Q. **Reference: 2026 GRA – Volume 1, Section 6.9.1 Rate Structure, p. 203 pdf**

Follow-up to IOC-NLH-001 (Attachment #1) and LAB-NLH-029 and LAB-NLH-030

Figure 1: Provincial Generation and Transmission Grid Labrador East

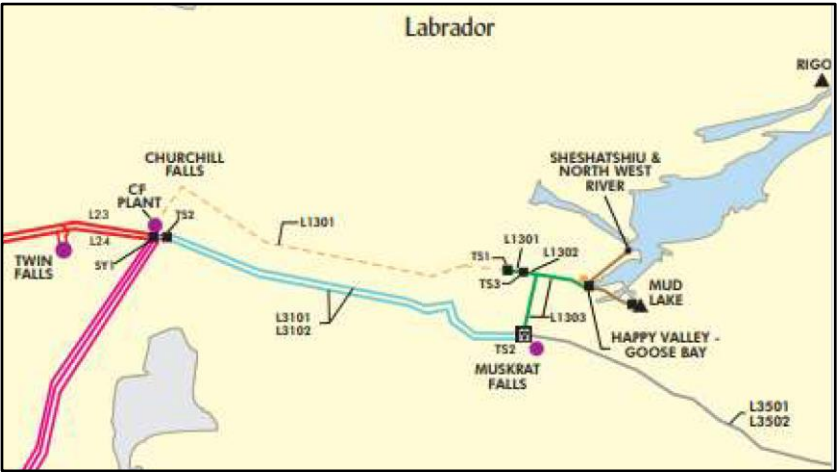
Based on the system configuration in Figure 1, TS1 appears to be behind TS3, and appears to service only an out of service (and soon to be decommissioned) L1301. TS3 appears on the system map of the LIS but is not listed among Capital Additions Labrador Interconnected System in response to IOC-NLH-001. The system maps contained in the NLSO 2026 Annual Planning Assessment are not sufficiently detailed (and potentially inaccurate) for determining which system assets are part of the LIS (and in the LIS rate base) and which part of the Labrador Transmission Assets (and in the IIS rate base).

- d)** Please clarify whether Muskrat Falls Terminal Station 1 in Capital Additions Labrador Interconnected System filed in IOC-NLH-001 refers to the terminal station labelled in Figure 1 as “TS1” at the eastern terminus of L1301 and, if not, to what it refers.

- e)** Please indicate whether NLH intends to decommission TS1 shown in Figure 1 as part of the decommissioning of L1301 and, if not, why not.
- f)** Please confirm that the ~\$0.675 million capital costs of Muskrat Falls Terminal Station 1 in Capital Additions Labrador Interconnected System filed in IOC-NLH-001 represent the entirety of the capital costs of this asset. If not, indicate which other portions are contained in the Labrador Transmission Assets, in Muskrat Falls or elsewhere.

- g)** Please clarify whether Muskrat Falls Terminal Station 2 in Capital Additions Labrador Interconnected System filed in IOC-NLH-001 refers to the terminal station labelled in Figure 1 as “TS2” adjacent to the CF Plant generating station, to the terminal station labelled in Figure 1 as “TS2” adjacent to the Muskrat Falls generating station, to both, or to something else.

- i)** Please indicate whether TS3 exists on the LIS and, if it is on the LIS, explain why no capital costs are allocated to it in Capital Additions Labrador Interconnected System filed in IOC-NLH-001.

- 9 **c)** It is confirmed.
- 10 **d)** Muskrat Falls Terminal Station 1 in Capital Additions Labrador Interconnected System filed
11 in Hydro’s response to IOC-NLH-001 of this proceeding refers to the terminal station labelled
12 in Figure 1 as “TS1”.

- 13 **e)** No, Hydro does not intend to decommission MFA TS1 as there are still assets in service that
14 are supplied from this terminal station.
- 15 **f)** It is confirmed.

- 16 **g)** Muskrat Falls Terminal Station 2 is TS2 adjacent to the Muskrat Falls Hydroelectric
17 Generating Station.
- 18 **h)** It is confirmed.
- 19 **i)** TS3 is part of the Labrador Interconnected System but was constructed for the supply of
20 construction power to Muskrat Falls and so is included in Muskrat Falls costs for which
21 Hydro is 100% responsible. No costs are allocated to the Labrador Interconnected System
22 because OC2013-343 directs that all such costs *"shall be included as costs, expenses or*
23 *allowances, without disallowance, reduction or alteration of those amounts, in*
24 *Newfoundland and Labrador Hydro’s cost of service calculation in any rate application and*
25 *rate setting process, so that those costs, expenses or allowances shall be recovered in full by*
26 *Newfoundland and Labrador Hydro in Island interconnected rates."*
